# SERVICE BULLETIN

No.301A

Piper Aircraft Corporation

Subject: Reissued Airplane Flight Manual and New Placards (Reference FAA Airworthiness Directive for PA-30 dated November 5, 1969)

Serial numbers 30-1 to 30-1716 inclusive, 30-1718 to 30-1744 inclusive

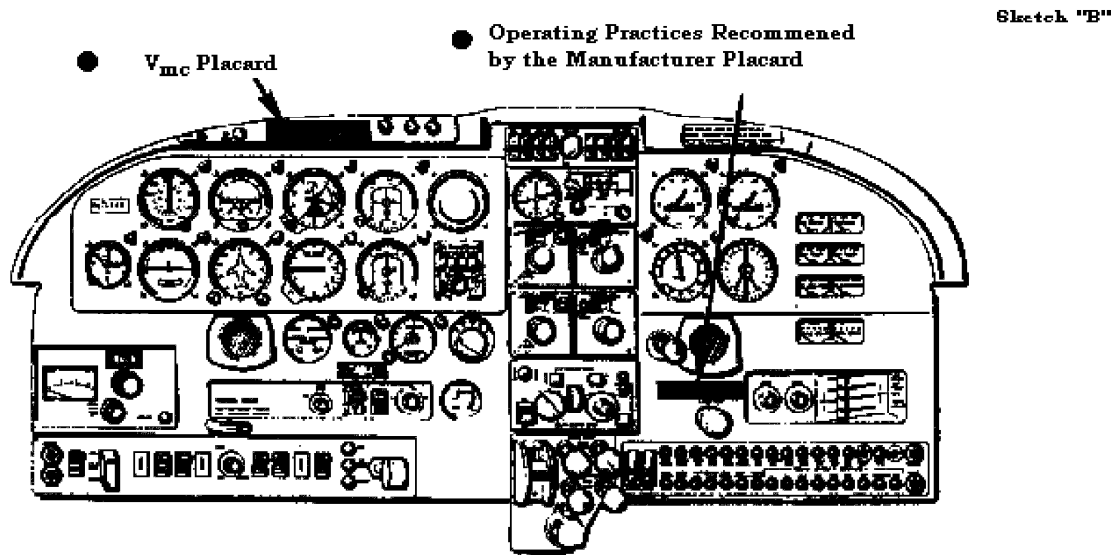
- I. Aircraft serial numbers 30-1 to 30-1716, 30-1718 to 30-1744 incl.:
  - A. Remove or cover existing minimum single engine control speed placard and install new Vmc placard, per sketch A, of this bulletin.

- B. Install new operating practices recommended by the manufacturer placard, located as denoted on Sketch A, of this bulletin.
  - C. Replace existing Section 1, Airplane Flight Manual Report No. 1269 with reissued Section 1 (reissue date 11/15/69), Airplane Flight Manual Report No. 1269, supplied with Vmc Placard Installation Kit part number 760 354 (reference Material Required, below).
